NOTICE OF ADDENDUM
ADDENDUM NO. 2
City of Madison, Engineering Department

CONTRACT NO. 8981
METRO TRANSIT PHASE 3A – MAINTENANCE AND DRIVER FACILITY IMPROVEMENTS

This addendum is issued to modify, explain or correct the original Drawings, Specifications, or Contract Documents marked as *Metro Transit Phase 3A–Maintenance and Driver Facility Improvements, City of Madison, Contract #8981, as issued on April 8th, 2021* and is hereby made a part of the contract documents.

4 6" DIAMETER GALVANIZED BOLLARD POST DETAIL
NOT TO SCALE

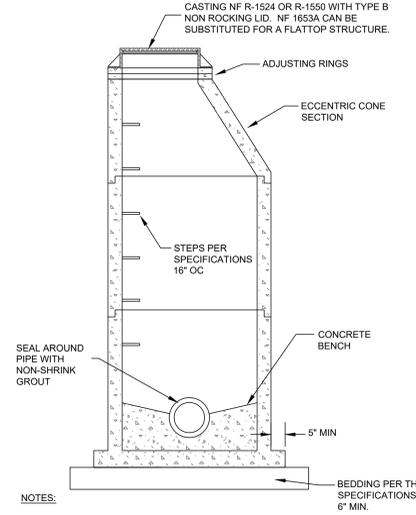
- i. Drawing C-101 (attached); Removed additional note to replace concrete sidewalk.
- ii. Drawing C-102 (attached); Provided a viewport for the bollards along the perimeter of the generator. Added annotation references for the viewport, detail reference, and separation distances.
- iii. Drawing C-141 (attached); Changed proposed 18” storm pipe to 12” and existing to 10”.
- iv. Drawing C-502 (attached); Added a 6” galvanized bollard detail.

S-101A

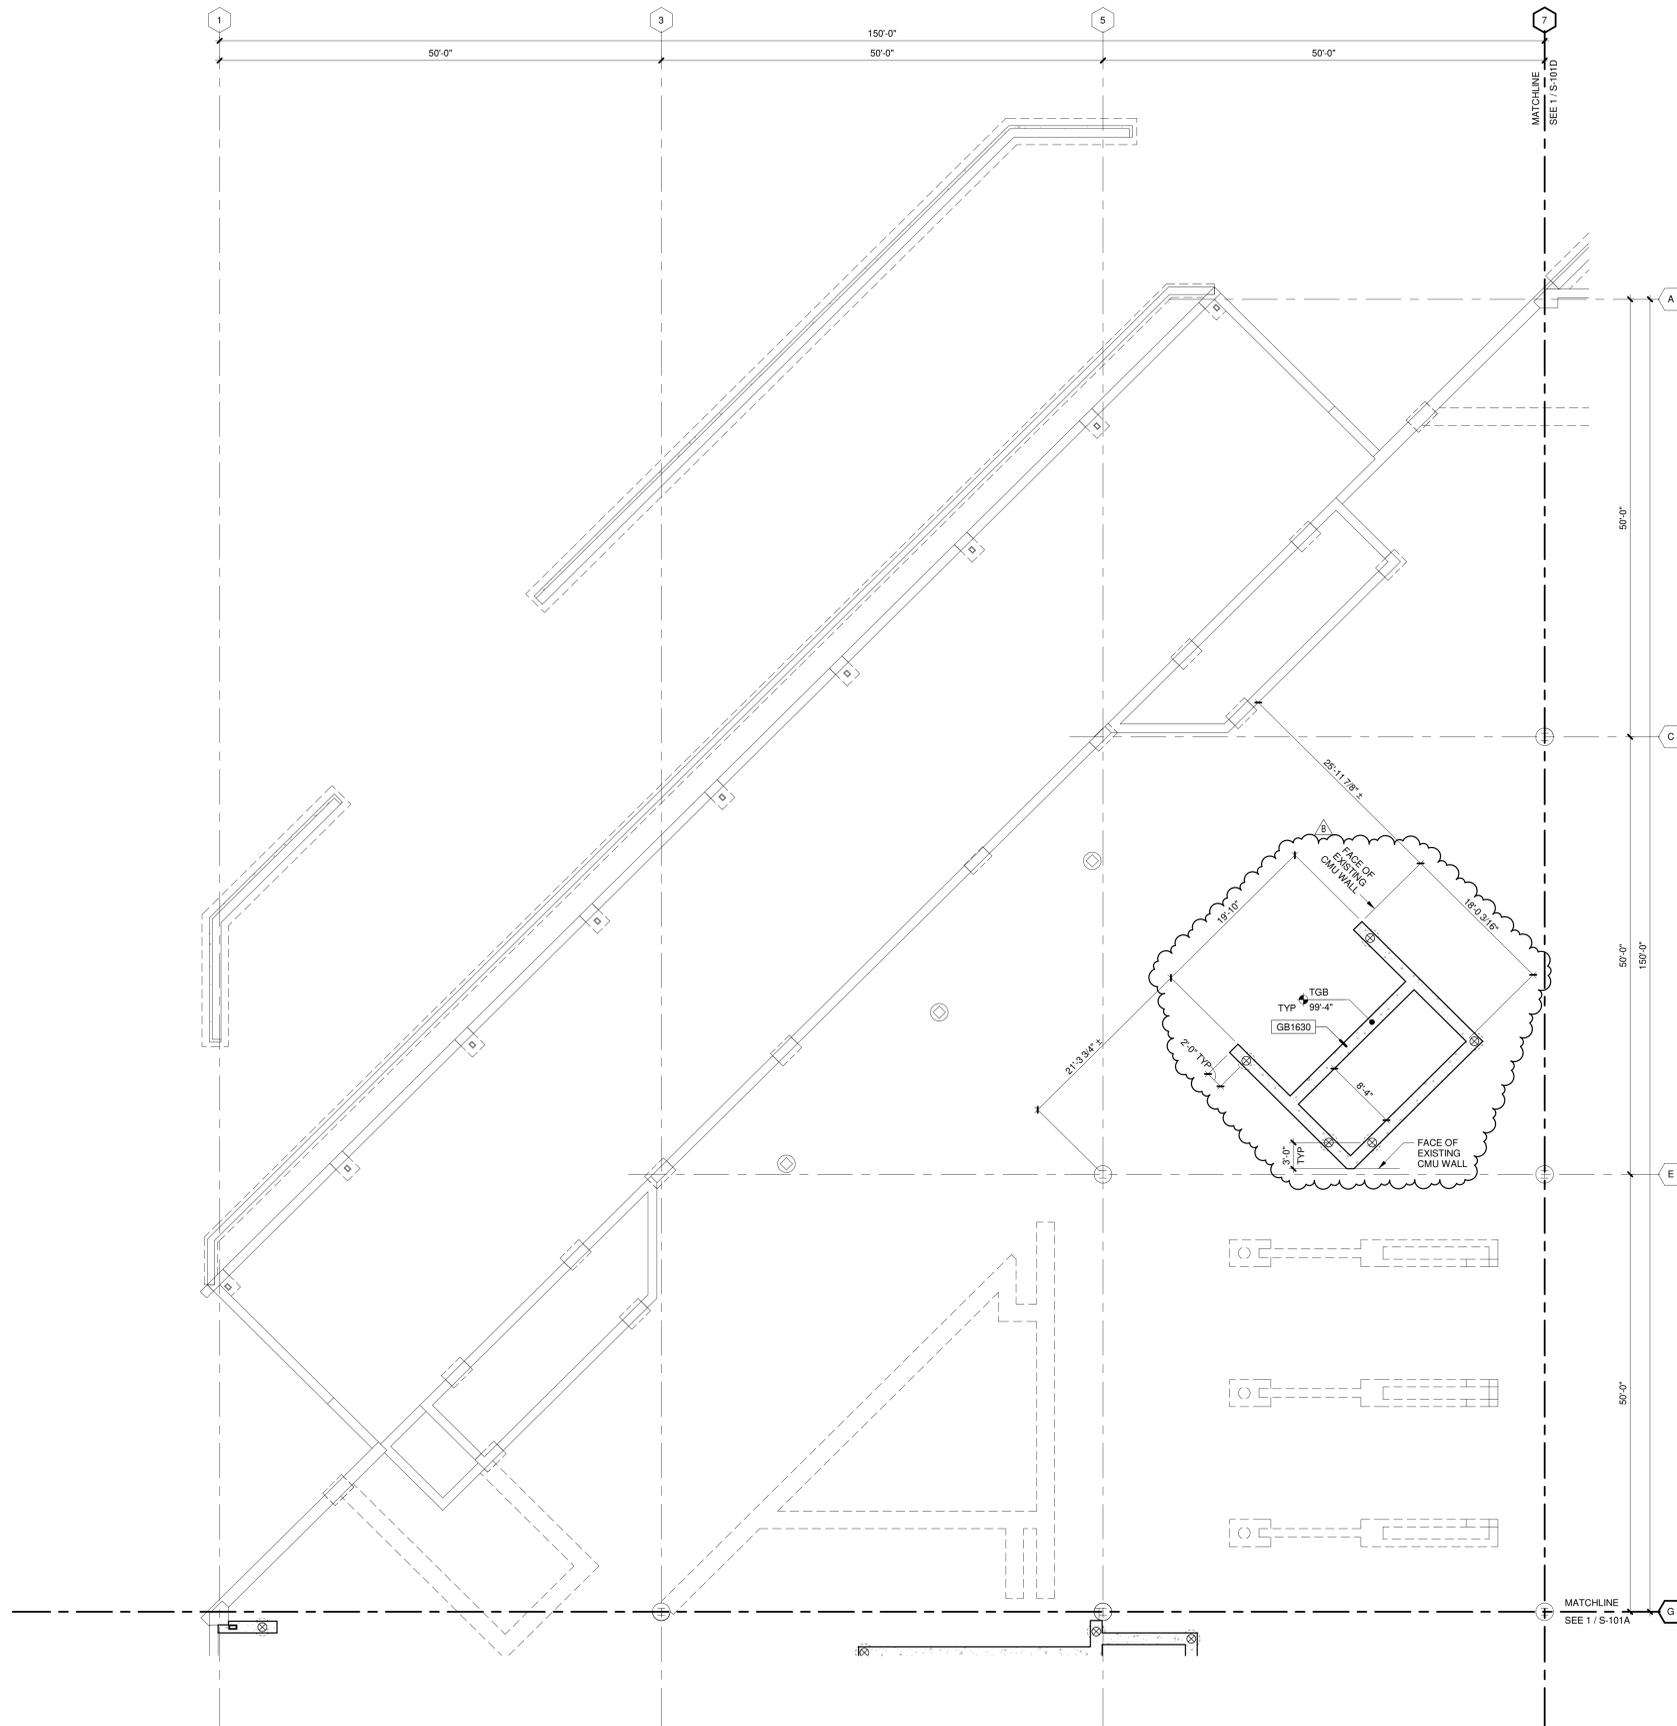
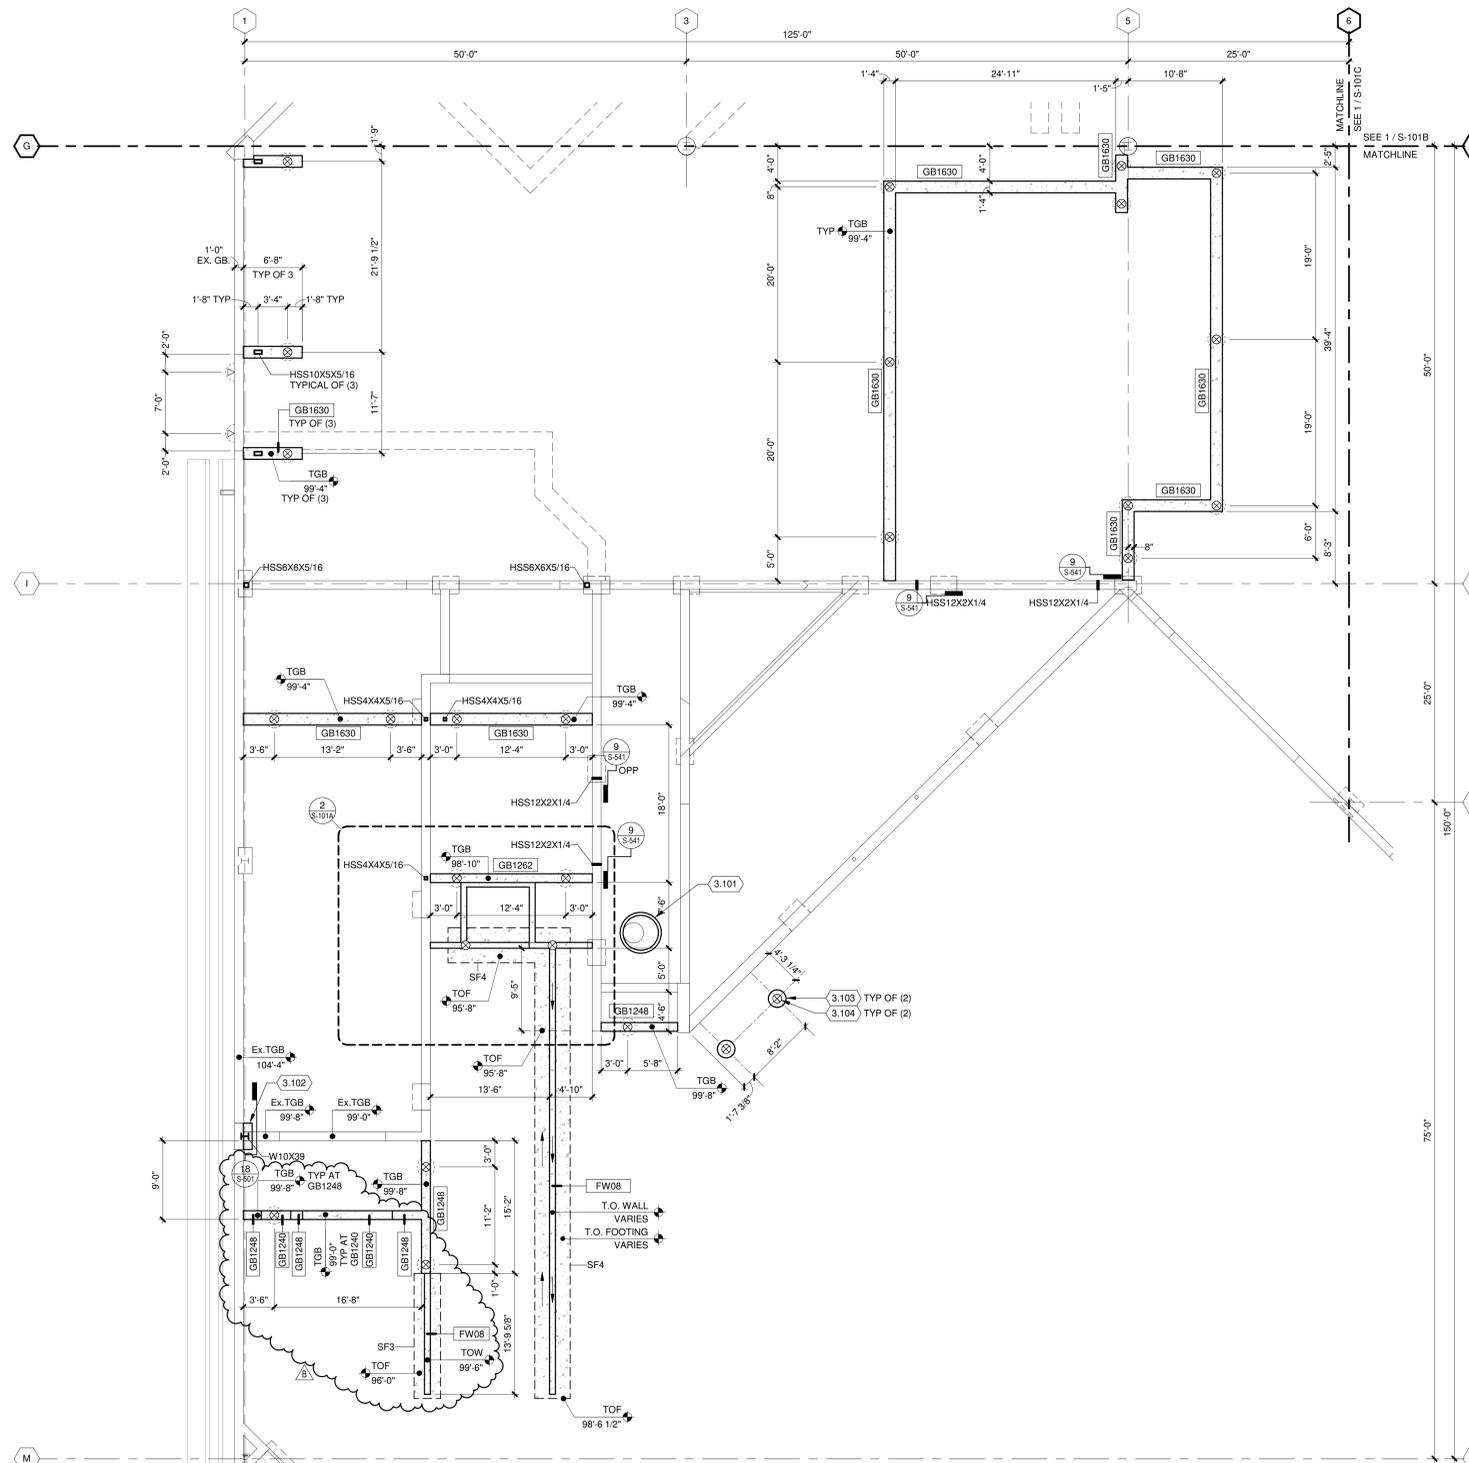
- iv. Drawing S-101A (attached); Strip footing schedule added, foundation added at end of truck dock.
- v. Drawing S-101B (attached); Added foundation for electrical room.

S-101C

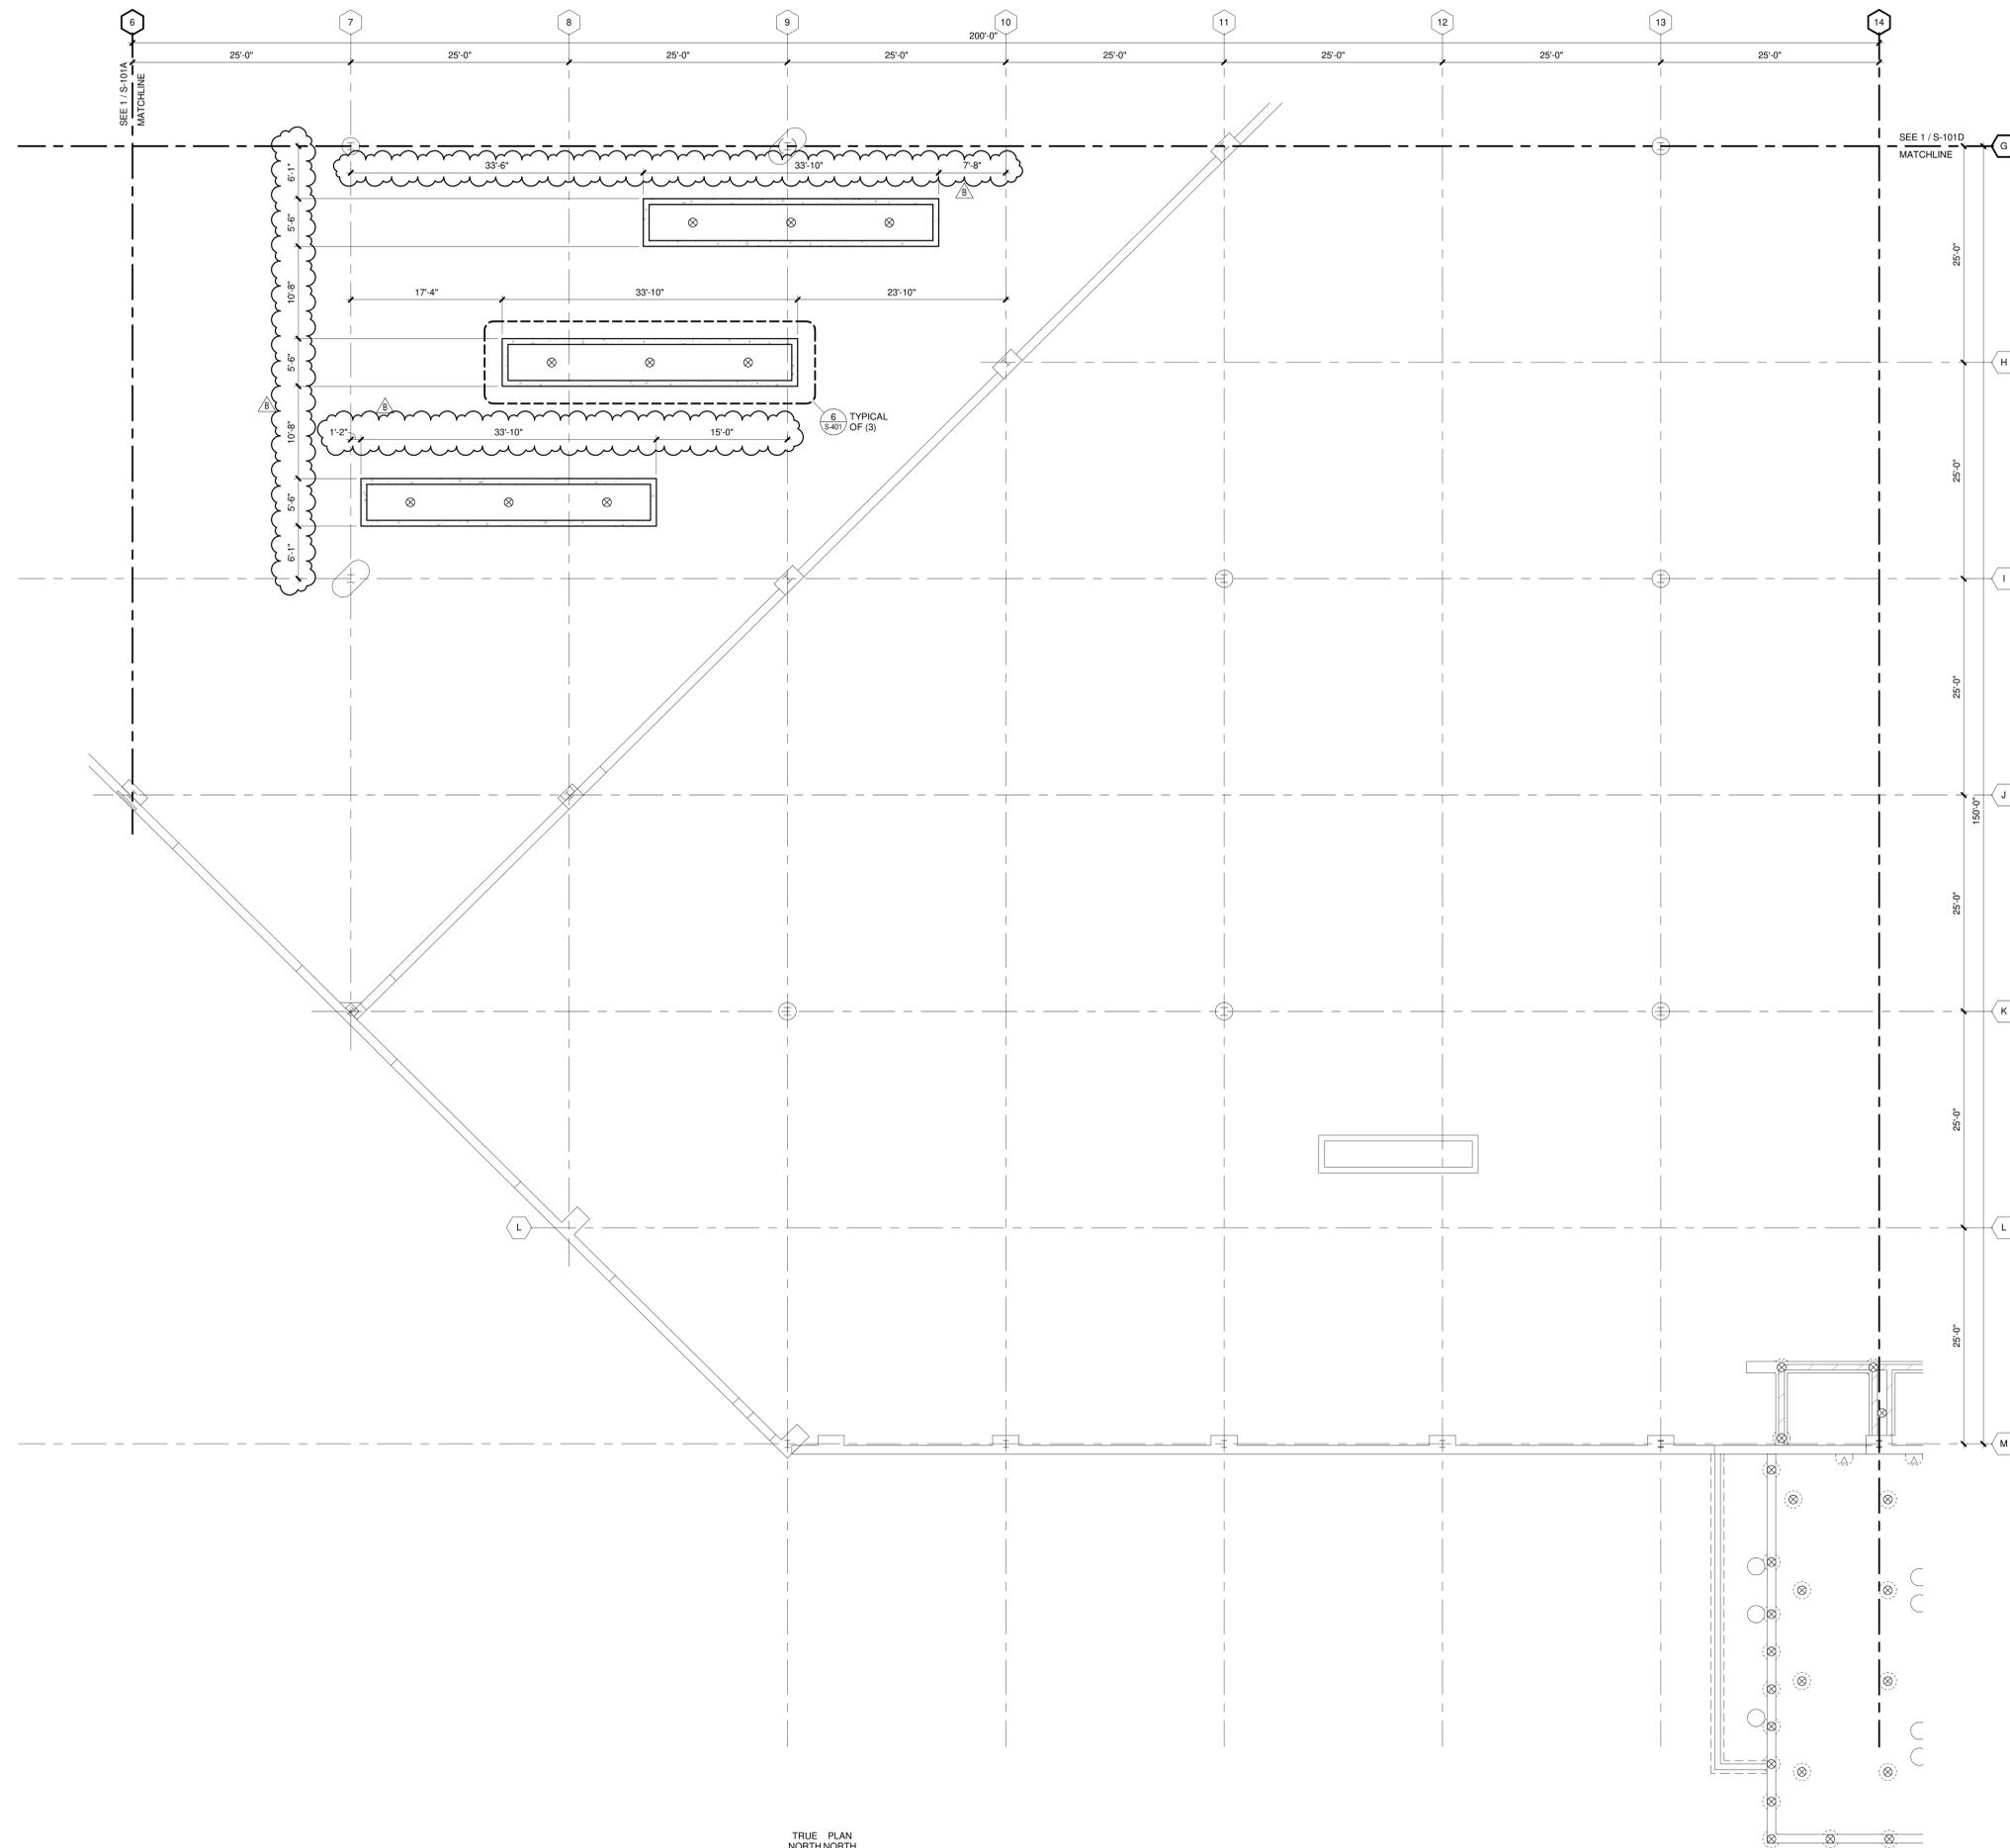
- vi. Drawing S-101C (attached); Added dimensions for pit foundations.
- vii. Drawing S-101D (attached); Added dimensions for pit foundations.
- viii. Drawing S-111A (attached); Paving added at end of truck dock.
